Rezoning Transportation Analysis

Petition Number: 2020-134

General Location Identifier: 05548104, 05548107, 05548105

Date	Description
10-20-2020	First Review (KP)
11-30-2020	Second Review (KP)
12-28-2020	Third Review (KP)

3. Right-of-Way Dedication:

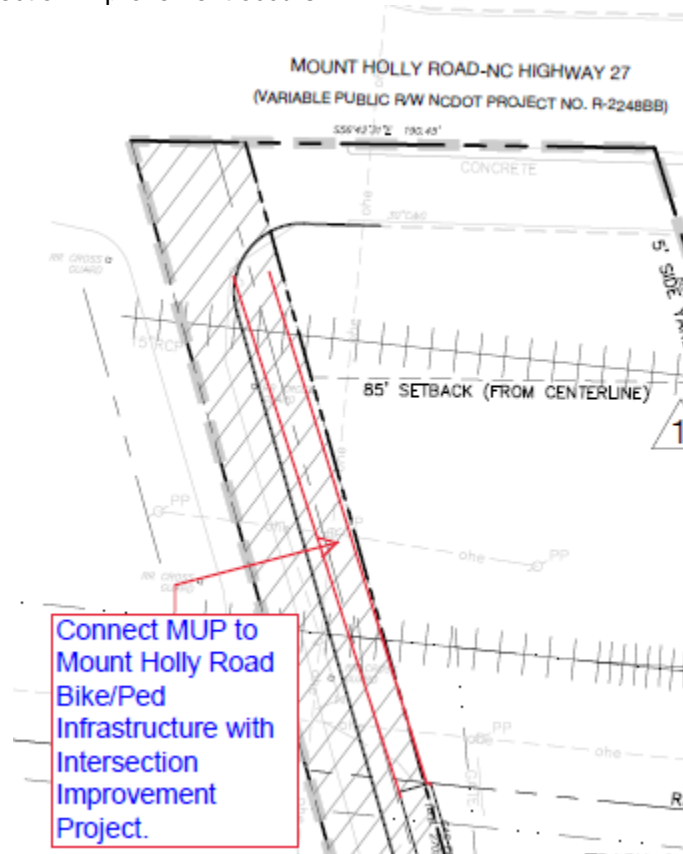
- a. ~~Mt. Holly Road:~~ Revise the site plan and conditional note(s) to commit to dedicate 55-feet of right-of-way from the road centerline. ~~Update as a result from 11-16-2020 Site Plan:~~ Dedicate as much ROW as possible without encroaching into the Railroad ROW.
- b. ~~Rhyne Road:~~ Revise the site plan and conditional note(s) to commit to dedicate 41-feet of right-of-way from the road centerline. ~~Update as a result from 11-16-2020 Site Plan:~~ 40-feet of ROW dedication is acceptable.

The site plan should label and dimension the right-of-way from the road centerline.

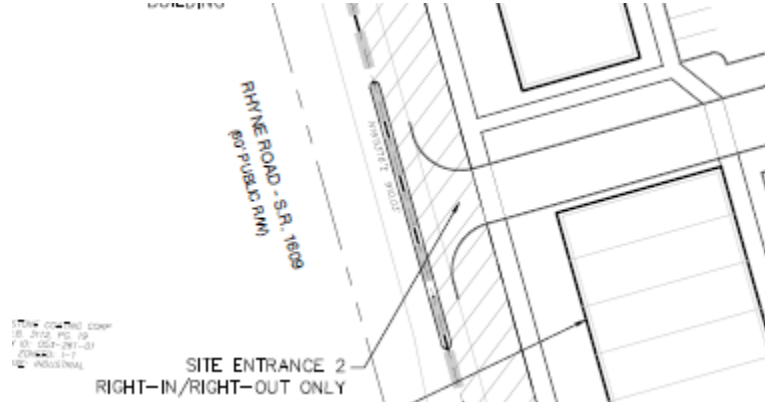
6. Revise the site plan and conditional notes to commit to the construction of a three-lane cross section, as shown below, along the site's Rhyne Road frontage. Add to the conditional notes that center turn-lane storage and tapers will be coordinated with NCDOT during plan permitting.
 - a. ***Advisory Comment*:** In accordance with the construction of the 12-foot multi-use path as noted in item 4 of this CDOT memo, the 5-foot bike lane, as depicted in the cross section below, may be excluded.
